This document was prepared by Yong Kim and Geoff Garner.

Revision 2, July 19, 2011

Figure 11-2 – Transport of time-synchronization information

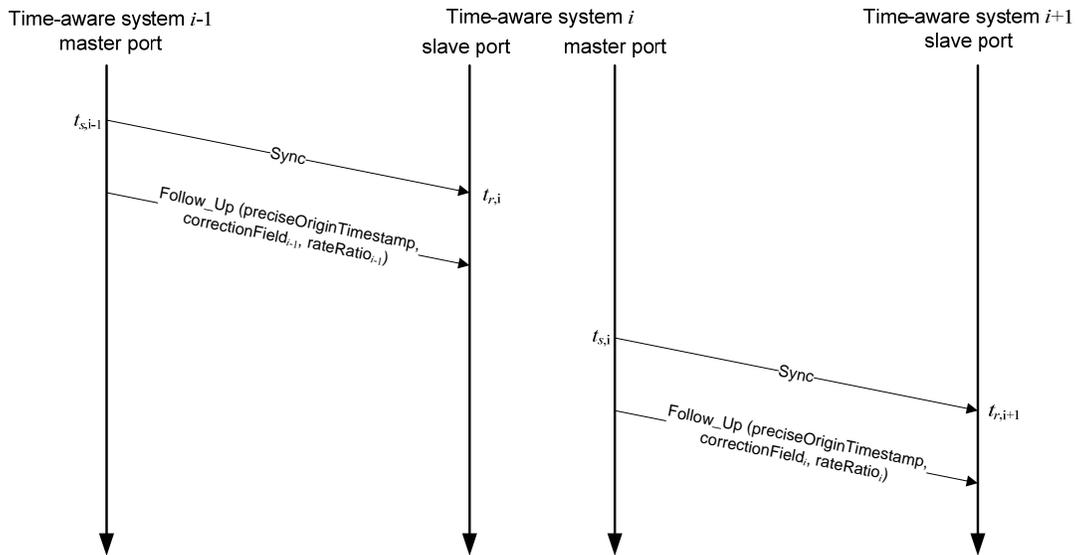
Change the Text of 11.1.3, as shown

The mean propagation delay on the link between time-aware systems $i-1$ and i , relative to the LocalClock entity of time-aware system $i-1$, is equal to neighborPropDelay (see 10.2.4.7). This must be ~~divided~~ multiplied by rateRatio $_{i-1}$ to express it in the grandmaster time base. The total propagation delay is equal to the mean propagation delay plus the quantity delayAsymmetry (see 8.3 and 10.2.4.8); delayAsymmetry is already expressed in the grandmaster time base. The residence time, $t_{s,i}-t_{r,i}$, must be multiplied by rateRatio $_i$ to express it in the grandmaster time base.

Figure B.3 – PTPDEV limit corresponding to wander generation requirement of Figure B.1

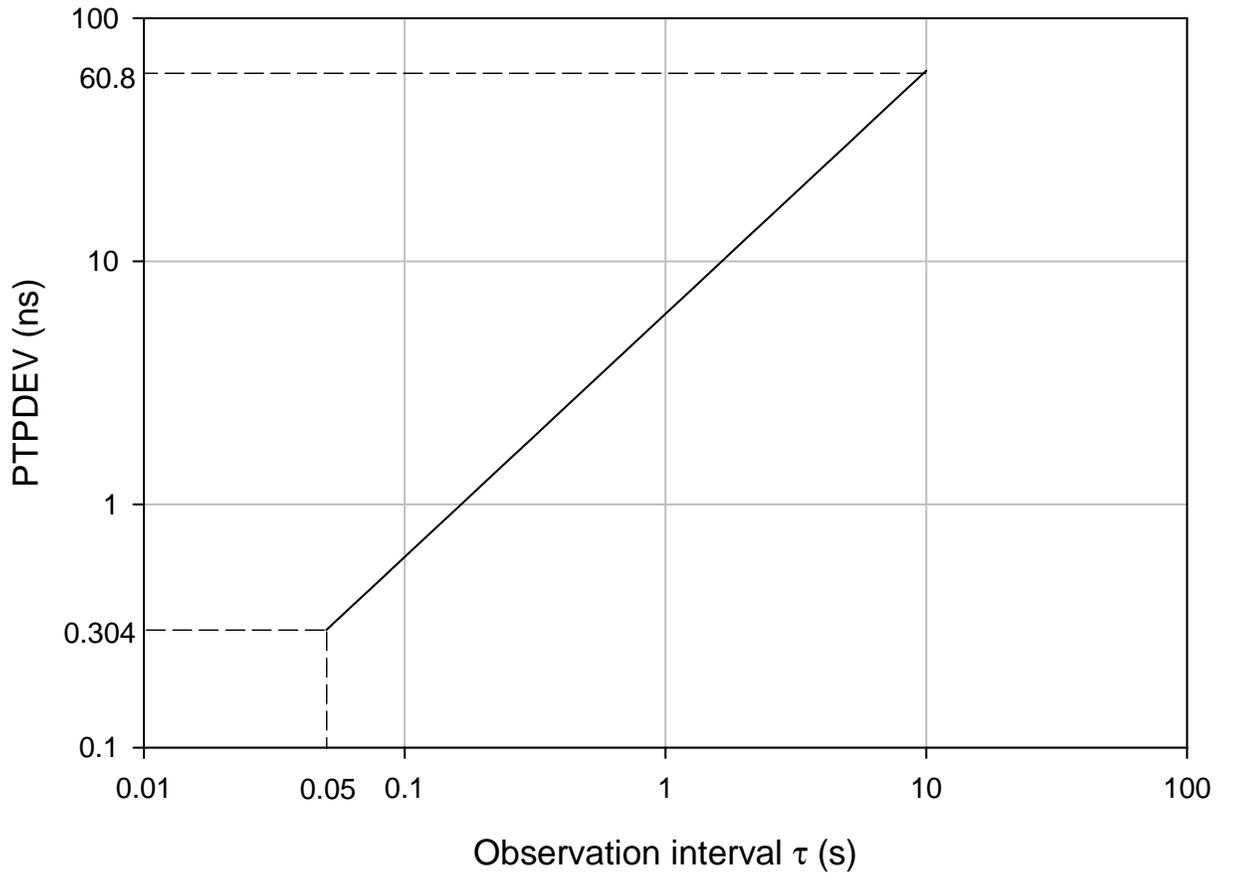
Change the Text of B.1.3.2, as shown

$$\sigma_{PTP}(\tau) = \sqrt{\frac{1}{6n^2(N-2n)} \sum_{i=1}^{N-2n} (x_{i+2n} - 2x_{i+n} + x_i)^2}, \quad n = 1, 2, \dots, \left\lfloor \frac{N-1}{2} \right\rfloor$$

$$\sigma_{PTP}(\tau) = \sqrt{\frac{1}{6(N-2n)} \sum_{i=1}^{N-2n} (x_{i+2n} - 2x_{i+n} + x_i)^2} \quad , \quad n = 1, 2, \dots, \left\lfloor \frac{N-1}{2} \right\rfloor$$
